Access Audit Site Report

Resaca de la Palma State Park
1000 New Carmen Ave
Brownsville, TX 78520
Accessibility Evaluation
Inspection Date: 07/12/2022
Inspectors: Tanya Scheibe

Prepared By
WT Group

**AMERICANS WITH DISABILITIES ACT COMPLIANCE INITIATIVE
PROGRAM AND POLICY REPORT
JULY 28, 2023**

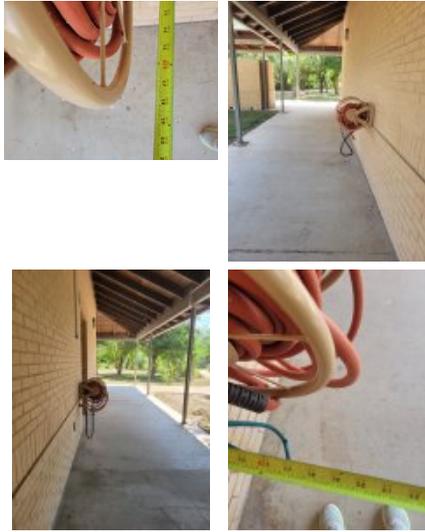
Finding Number	Area Description	Lat/Long	Finding	As Built	Recommendation	Citation	Photos	Figure
6	Exterior: Parking	[25.9966133 , -97.569741 7]	The accessible route of travel that crosses or adjoins the vehicular way and the walking surface is not separated by curbs, railings, or other elements between the pedestrian areas and vehicular areas.	Lacks detectable warning connecting to East parking, bus lot and parking area to visitor center	Install detectable warning where accessible route crosses the vehicular way as a smart practice.	2012 TAS Section: 705.1 2010 ADAS Section: 705		
7	Exterior: Exterior Accessible Route	[25.9969778 , -97.568999]	The walkway contains abrupt vertical edges and/or variations over a 1/4 inch. 1/4 inch is the maximum vertical rise. Changes in level between 1/4 inch and 1/2 inch must be beveled at 1:2 or less. Changes in level greater than 1/2 inch must be by way of a ramp.	1" change in level at restroom entry from crusher fine pathway	Repair, bevel or ramp CIL along AR.	2012 TAS Section: 303.2, 303.3 2010 ADAS Section: 303.2, 303.3

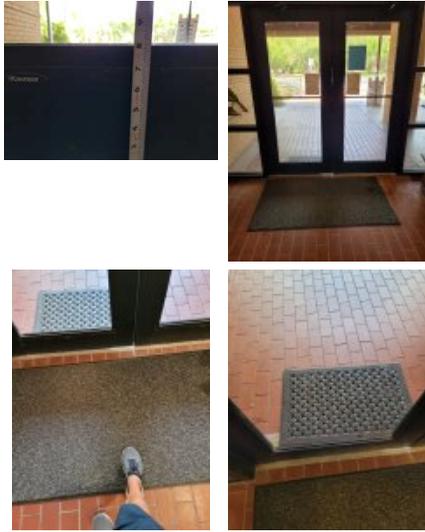
Finding Number	Area Description	Lat/Long	Finding	As Built	Recommendation	Citation	Photos	Figure
21	Headquarters (HQ) : HQ - Public Spaces	[25.9967392 , -97.5688113]	The clear floor space required at accessible drinking fountains is not positioned for a forward approach. Units shall have a clear floor or ground space positioned for a forward approach and centered on the unit.	13" clear floor space on forward approach due to wall, side approach only	Remount or relocate drinking fountain to provide a forward approach 30" X 48" CFS to the fountain.	2015 ABAAS Section: 602.2 2012 TAS Section: 602.2 2010 ADAS Section: 602.2		
22	Headquarters (HQ) : HQ - Public Spaces	[25.9967488 , -97.5688059]	There is not enough knee clearance under the drinking fountain. The drinking fountain must have a clear knee space between the bottom of the apron and the floor not less than 27 inches in height, 30 inches in width, and 8 inches in depth.	26" knee clearance	Raise drinking fountain to provide required 27" knee clearance.	2015 ABAAS Section: 602.2 2012 TAS Section: 602.2 2010 ADAS Section: 602.2

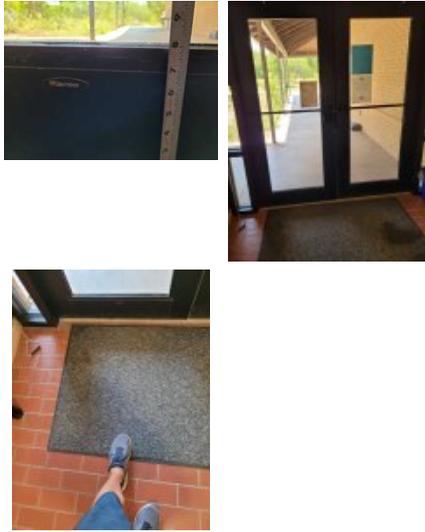
Finding Number	Area Description	Lat/Long	Finding	As Built	Recommendation	Citation	Photos	Figure
24	Headquarters (HQ) : HQ - Public Spaces	[25.996756, -97.5687603]	The route of travel at this location does not provide a minimum width of 36 inches. The clear width shall be permitted to be reduced to 32 inches minimum for a length of 24 inches maximum provided that reduced width segments are separated by segments that are 48 inches long minimum and 36 inches wide minimum.	31" between table and wall, 29" between table and walking sticks	Widen AR to compliant 36" clear width. Relocate furniture and storage.	2015 ABAAS Section: 403.5.1 2012 TAS Section: 403.5.1 2010 ADAS Section: 403.5.1		
25	Headquarters (HQ) : HQ - Public Spaces	[25.9967392, -97.5687844]	The operable part is positioned too high for either a side or front approach. Where a clear floor or ground space allows a parallel approach to an element and the side reach is unobstructed, the high side reach shall be 48 inches maximum and the low side reach shall be 15 inches minimum above the finish floor or ground. Where a forward reach is unobstructed, the high forward reach shall be 48 inches maximum and the low forward reach shall be 15 inches minimum above the finish floor or ground.	Juice 54" AFF, donate box 56.5" AFF	Remount operable parts to be in reach range of 15" min to 48" max	2015 ABAAS Section: 308.1 2012 TAS Section: 308.1 2010 ADAS Section: 308.1

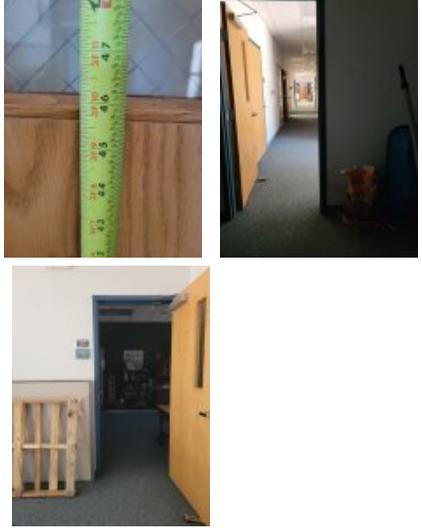
Finding Number	Area Description	Lat/Long	Finding	As Built	Recommendation	Citation	Photos	Figure
31	Headquarters (HQ) : HQ - Public Spaces	[25.9966201 , -97.568738 3]	Minimum maneuvering clearances at doors and gates shall comply with 404.2.4. Maneuvering clearances shall extend the full width of the doorway and the required latch side or hinge side clearance. The bottom 10 inches on the push side must be smooth and free of obstructions (hold open devices). Opening hardware must be mounted between 30 and 44 inches above the floor or ground.	Left exit doors to parking - window starts at 8", rug not secure, outdoor rug loose also	For all doors along the public circulation route, provide required maneuvering clearance on push and pull side of doors. For all doors along the public circulation route, secure rug in door clearance to prevent trip hazard. For all doors along the public circulation route, provide kick plate on push side of door from floor to 10" AFF.	2010 ADAS Section: 404.2.3, 404.2.7, 404.2.4, 404.2.11, 404.2.11 Exception

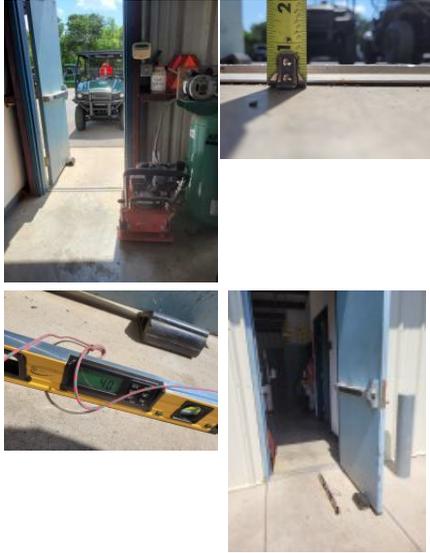
Finding Number	Area Description	Lat/Long	Finding	As Built	Recommendation	Citation	Photos	Figure
81	Employee Areas: Maintenance	[25.997636, -97.570672 7]	An item or items project more than 4 inches into the circulation path. Wall-mounted objects that have leading edges between 27 inches and 80 inches from the floor must not project more than 4 inches into the circulation path. Protruding objects that extend to the floor or within 27 inches of the floor are cane detectable and are therefore not hazardous. Where it is necessary or desirable to have objects protrude from the wall, a manner of cane detection must be provided.	Restroom - Lockers project 18" into circulation path	Relocate protruding objects or place cane detectable warning or bollard at foot of item.	2015 ABAAS Section: 307.2 2012 TAS Section: 307.2 2010 ADAS Section: 307.2		
82	Employee Areas: Maintenance	[25.9976408, -97.570694 2]	The accessible path of travel contains cross slopes greater than 2%. Surface cross slopes shall not exceed one unit vertical in 48 units horizontal (2-percent slope). When the slope in the direction of travel of any walk exceeds 1 unit vertical in 20 units horizontal (5-percent slope), it must be constructed as ramp.	Restroom - 3.7% near toilet	Correct or repair cross slope of AR to max 2.08%	2015 ABAAS Section: F206.2.4, 403.3 2012 TAS Section: 206.2.4, 403.3 2010 ADAS Section: 206.2.4, 403.3
